Comments on:

“Middlesex School East Fields Athletics – Drainage Calculations”
Samiotes Consultants, Inc., 16 November 2004

Massachusetts Department of Environmental Protection

March 24, 2005

Figure 1 – NHESP Classifications

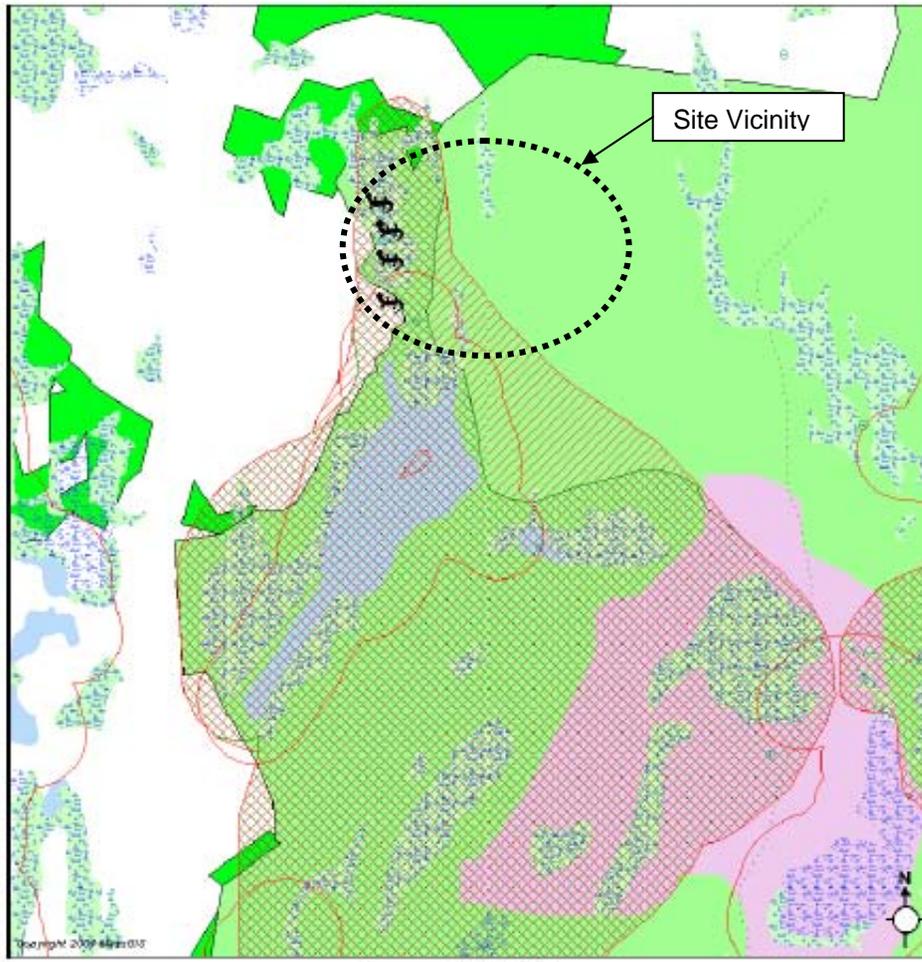
2. The proposed development is located in a portion of the Estabrook Woods designated by the Commonwealth as a “Priority Site” under National Heritage & Endangered Species Program. This priority is reflected by the fact that NHESP designations and Mass-GIS data layers for “Estimated Habitats for Rare Wildlife”, “Biomap Core Habitat”, “Certified Vernal Pools”, “Contiguous Open Space” all intersect the site (Figure 1). The site has “bordering vegetated wetlands” on at least three sides.

Figure 3- Site Elevation Profile

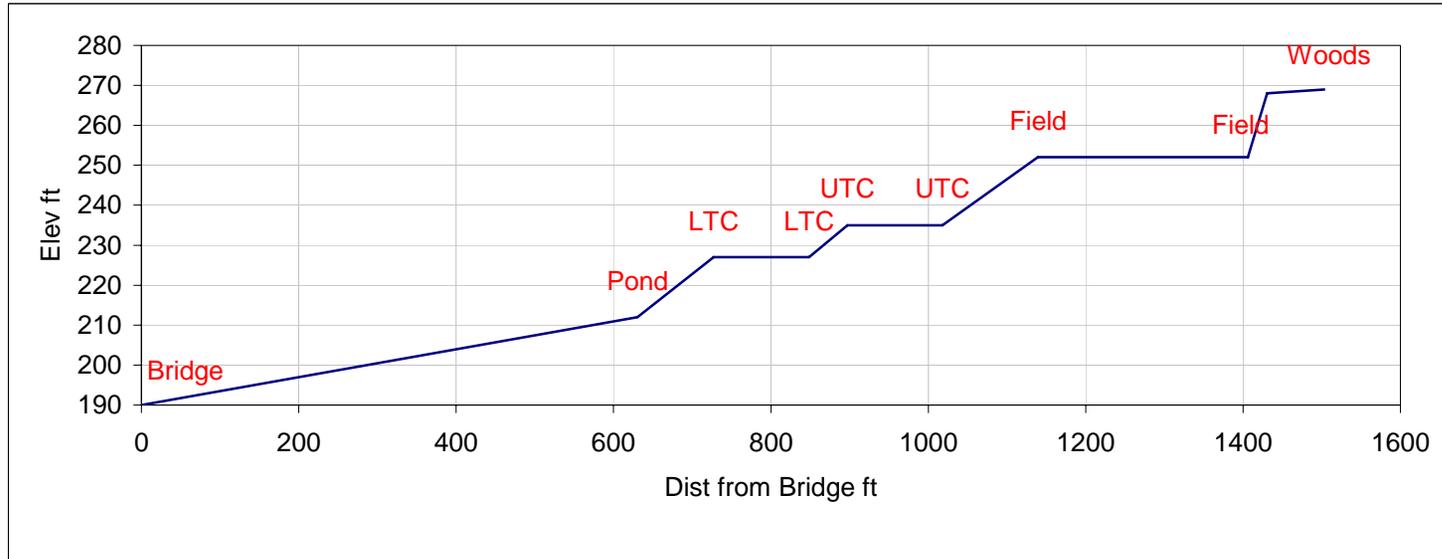
5. The proposed development extends approximately one-quarter mile into Estabrook Woods from the edge of the Middlesex campus (Figure 2). It is cut into the side of a hill with an average grade of ~6-7% (Figure 3). The maximum depth of the cut (in the southeastern corner of the Practice Field) is ~15 ft; i.e., the base of the field drainage system is ~15 ft below the existing land surface. The cut depth decreases to ~6 ft at the NE corner of the main soccer field. Maximum cut depths are 3-5 ft for the tennis courts. Based upon the topography and Plan geometry, I estimate that more than 40,000 yd³ of forest soil will have to be moved from the uphill sides of the fields & courts in order to create a level base. Presumably, this material will either be removed from the site altogether or used to fill the western downhill field sections. It is not clear whether the foundation for the fields (compacted base & stone) will be brought in from elsewhere or "mined" on site.

9. The Plan indicates that soils have perched seasonal high water tables ranging from 14 to 24 inches (Page 2). Given these geologic features and depth of the cuts (up to 15 ft, See 5 above & Figure 3), there is a high probability that the cuts will intersect existing groundwater tables. The drainage trenches beneath the fields may intercept this groundwater, but the amounts are not quantified. Therefore, there is no assurance that the drainage system (field/court under-drains, detention ponds, swales, infiltration basin, outlets) is designed to accommodate intercepted groundwater sufficiently to control peak discharge rates below the existing condition.
